CHANGE NOTICE

Effective Date: DECEMBER 1, 2011
Log Number: CN-04-433
Subject: MOV's PN 13012.29
Model Affected: EST44/66 CONVEYORS

MOV's

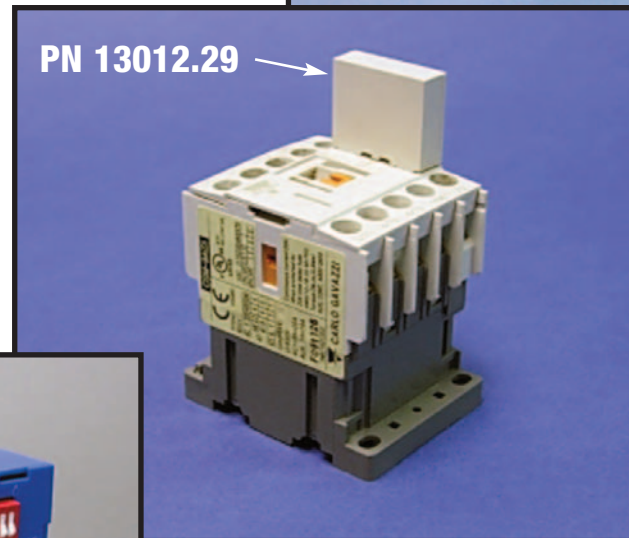
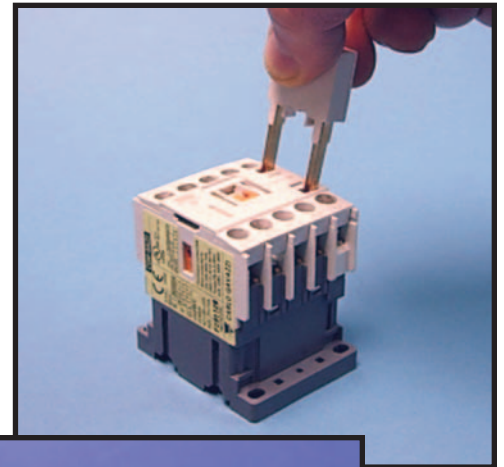
To maintain and balance voltage consistency to the various low voltage controls within the electrical system in EST-44/66 Conveyors, CMA has added MOV's (an electronic filter) to each of the motor and heater contactors. In addition, the conveyor timer relay has had an internal built-in MOV. This improvement to the Conveyor electrical system will provide added component protection in different areas of North America that experience voltage inconsistencies.
